Access Compliance Report Public Rights-of-Way (Curb Ramps)

Main Street: RANUNCULUS_ST Cross Street: LANGFORD_RD Location: N

ADA ID: RPRK211111120022 Ramp Type: Type 4 - Parallel Initial Pass/Fail: Fail Overall Compliance: No Severity Score: 32

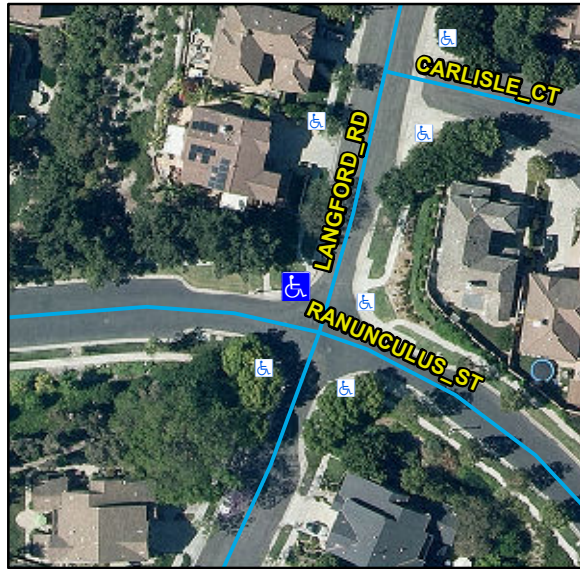
Compliance	Description	Data	Compliance	Description	Data
N/A	Ramp Length LT (in)	136	N/A	Ramp Length RT (in)	139
Yes	Ramp Width LT (in)	54	Yes	Ramp Width RT (in)	54
Yes	Ramp Run Slope LT (%)	6.6	No	Ramp Run Slope RT (%)	14.7
Yes	Ramp Cross Slope LT (%)	1.8	No	Ramp Cross Slope RT (%)	2.3
N/A	Landing Present	N/A	N/A	DWS Provided	N/A
N/A	Landing Length (in)	N/A	N/A	DWS Contrast	N/A
N/A	Landing Width (in)	N/A	N/A	DWS Length (in)	N/A
N/A	Landing Run Slope (%)	N/A	N/A	DWS Full Width	N/A
N/A	Landing Cross Slope (%)	N/A		DWS Offset Type	N/A
N/A	Landing Movement Obstructed?	N/A	N/A	DWS Offset Left (in)	N/A
	Landing Movement Type	N/A	N/A	DWS Offset Right (in)	N/A
N/A	Landing Shared	N/A			
N/A	Clear Space	Yes			
N/A	Clear Space To Crosswalk (in)	N/A			
N/A	Marked Crosswalk 1	No	N/A	Marked Crosswalk 2	No
	Crossing 1 Direction	SE		Crossing 2 Direction	SW
N/A	Marked Crosswalk 1 Width (in)	N/A		Marked Crosswalk 2 Width (in)	N/A

N/A	Ramp Inside Crosswalk 1	N/A	N/A	Ramp Inside Crosswalk 2	N/A
	Crossing 1 Slope (%)	9.7		Crossing 2 Slope (%)	10.5
	Crossing 1 Cross Slope (%)	9.9		Crossing 2 Cross Slope (%)	3.1
N/A	Gutter Ponding	N/A	N/A	Curb Slope	6.4
Yes	Gutter Lip Height (in)	0		Road Run Slope (%)	6.8
N/A	Gutter Run Slope (%)	N/A		Road Cross Slope (%)	7.7
N/A	Gutter Cross Slope (%)	N/A	No	Perpendicular Joint Present	No
Yes	Overall Surface Condition	Acceptable			
	Cross Gutter Present?	No		Spandrel Present?	No
	Replace Cross Gutter?	N/A		Replace Spandrel?	N/A

Remove & Replace Curb Ramp With Two New Directional Ramps or Equivalent.

R204.3, R304.3.2, R304.5.3, STD 1115
